Draft Report - Chehalis River Hydraulic Model Development Project

Prepared by:
WATERSHED Science & Engineering
and
WEST Consultants

Prepared for:
Chehalis River Basin Flood Authority

WSE Response to State Tech Team Comments on Hydraulic Model (4/17/2012)

Figure 1. Flood Return Periods at Various Gaged Sites for the February 1996 Event

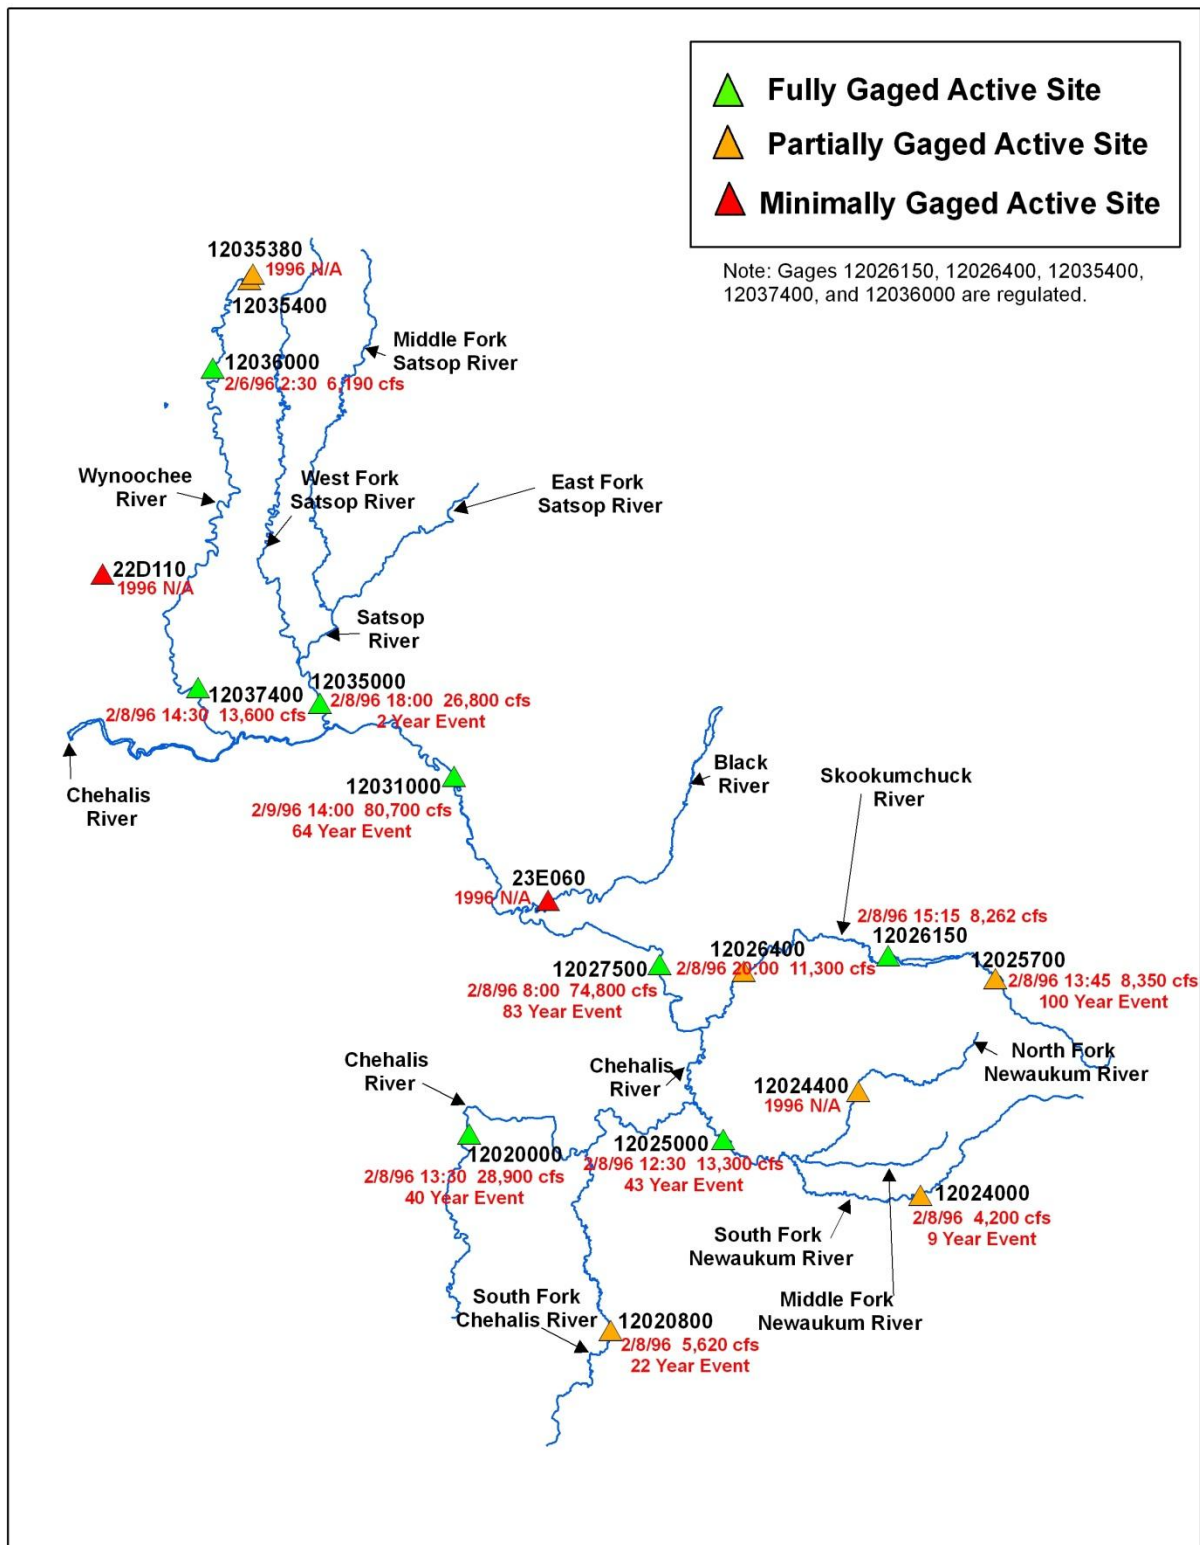
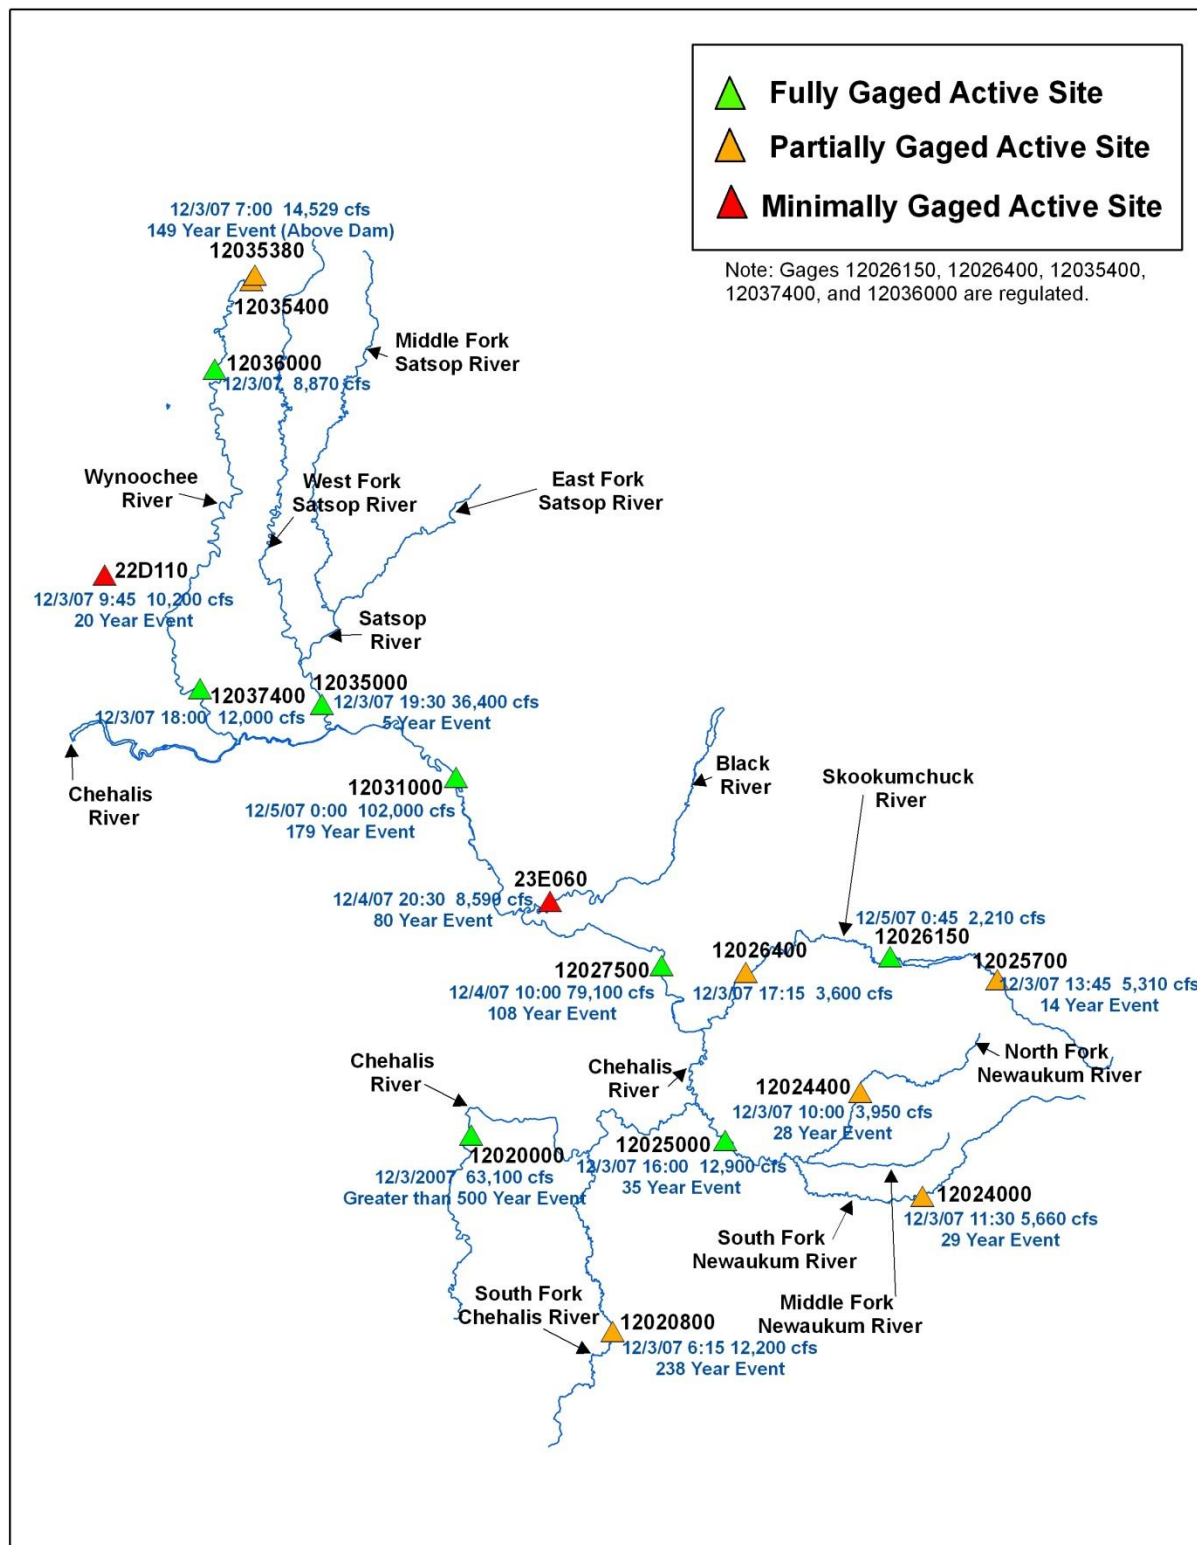
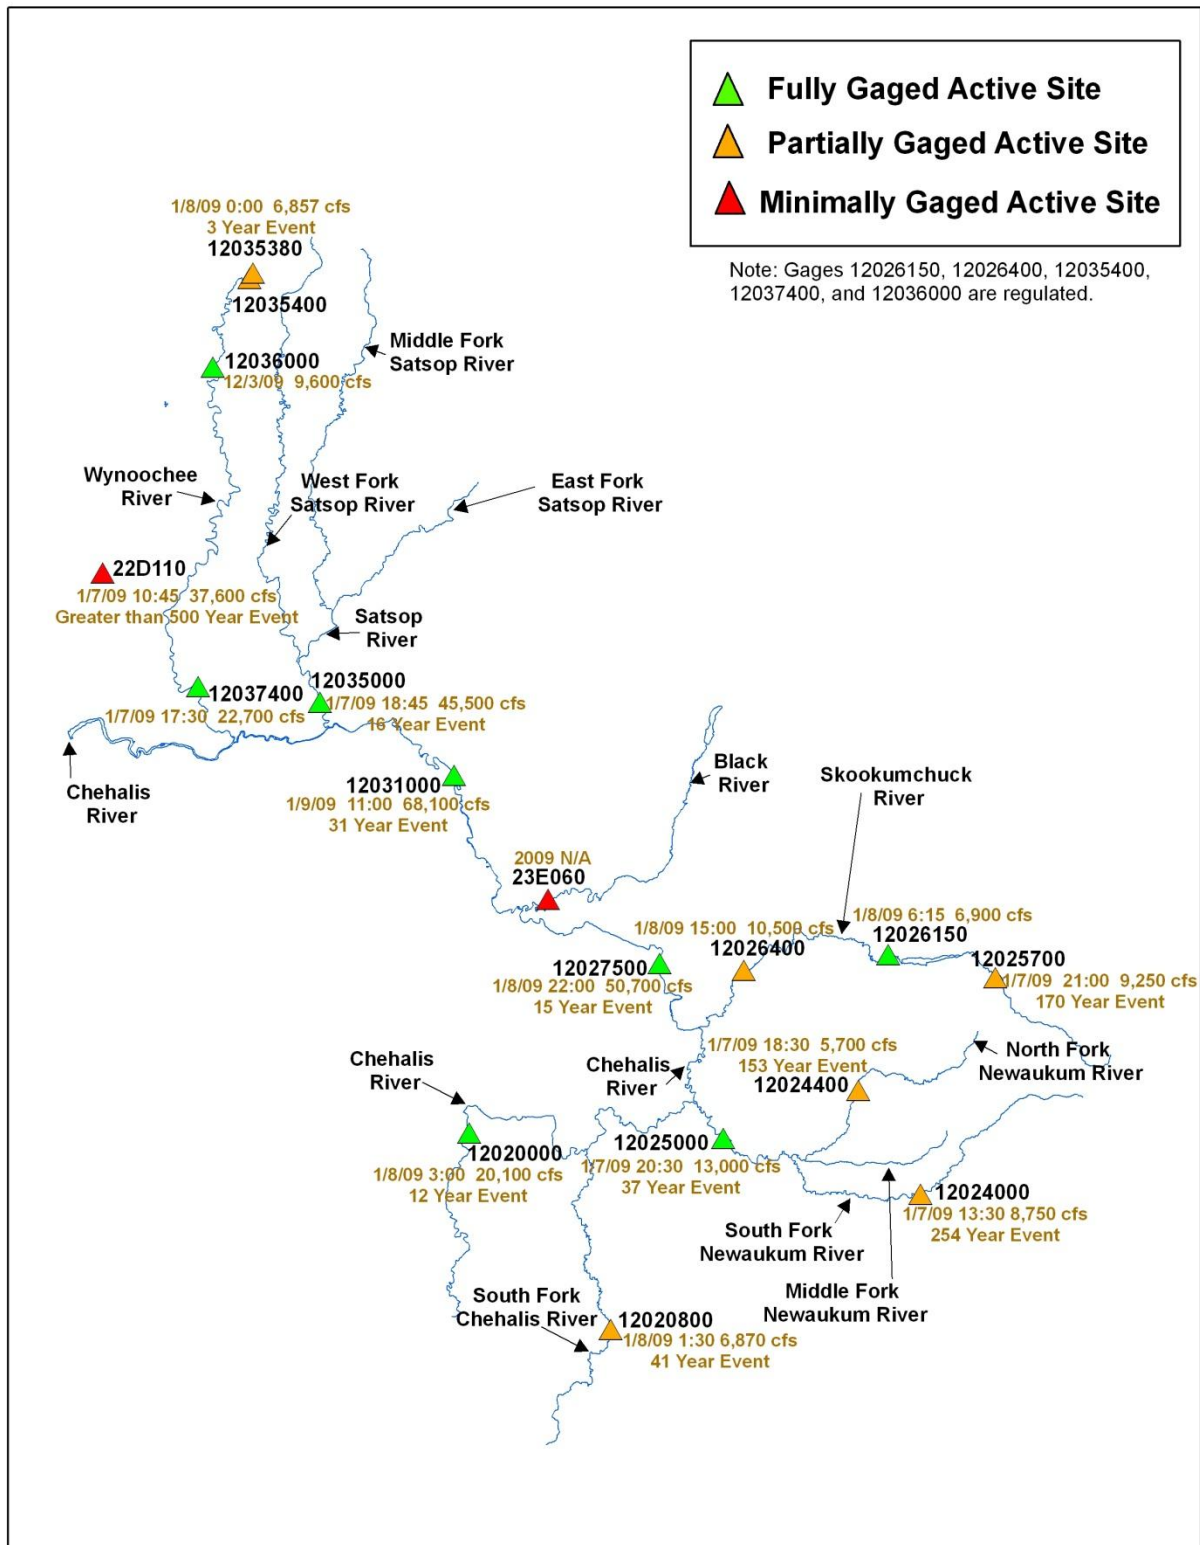
RE: Paul Pickett comment letter of 3/30/2012:

Mr. Pickett's comments focused primarily on the hydrologic data proposed for use in the evaluation of flood relief alternatives. He noted that flood events in a basin as large and complex as the Chehalis Basin can come in many different forms and that a comprehensive analysis of flood relief alternatives would require a range of design events to be simulated. However, in our response below we provide data showing that the largest flood events (i.e. the top 10 floods) observed in the Chehalis basin in the past 80 years have similar enough characteristics to make the proposed design event modeling approach reasonable for the current effort. Furthermore, we note that the hydrology for the current study was done and widely reviewed as part of the concurrent Corps project and using the same hydrologic methodology as that study will maintain consistency between the modeling efforts. However, in an effort to provide a more robust and useful analysis, we offer a recommendation to use

In Mr. Pickett’s comment letter he plots the correlation between the annual peak discharges near Grand Mound and near Doty with and without inclusion of the December 2007 event. The figure shows that for flows in the Chehalis River near Grand Mound less than about 45,000 cfs, roughly the peak discharge of a 10-year event (Table 1), the two regression curves are relatively close to each other. For flows that exceed about 45,000 cfs, the regression curves depart significantly. Mr. Pickett expressed concern that the higher ratio of flows near Doty to flows near Grand Mound might result in unreasonably large contributions from the upper watershed (above Doty), even though this is only seen in some of the observed flood events.

Furthermore, review of the concurrent USGS gage records for Doty and Grand Mound shows that of the top 10 historical flood events at Doty, eight were also in the top 10 events of all time at Grand Mound. Similarly, of the top 10 events on the South Fork Chehalis River and the Newaukum River 7 were also among the top 10 events at Grand Mound. However, it can be seen that of the top 10 flood events on the Skookumchuck River only four were in the top 10 flood events at Grand Mound. Looking in more detail at the Skookumchuck gage records it can also be seen that the 2nd highest flow of all time on the Skookumchuck was only the 24th highest flow at Grand Mound and the 4th highest flow on the Skookumchuck was only the 23rd highest flow in the USGS record at Grand Mound.

Using the top 10 flows at Grand Mound as a representative and sufficiently large sample of basin wide flood events, we see that the average contributions from Doty, South Fork, Newaukum, and Skookumchuck during these events are 45%, 17%, 19%, and 14% of the Grand Mound peak. In his comments Mr. Pickett noted that the preliminary proposed design flow hydrology had ratios of 44%, xx% (South Fork is under review), 17%, and 14%, respectively, for these locations. The proposed design flow ratios appear to be very reasonable given the data in Table 2 and the observations listed above. Figure through Figure show the distributions of flood return periods across the entire basin for the February 1996, December 2007, and January 2009 events. For the January 2009 event, a flood event greater than the 100-year peak discharges occurred in the Skookumchuck and Newaukum Rivers. However, the corresponding flows near Doty and near Grand Mound are only a 12-, and 15-year event, respectively. Thus, while this event is a good example that portions of the basin can see extreme floods while other portions see smaller flood events it also supports the conclusion that a basin-wide extreme flood (as determined using the gage at Grand Mound) is only possible with a large contribution from the Upper Chehalis basin.
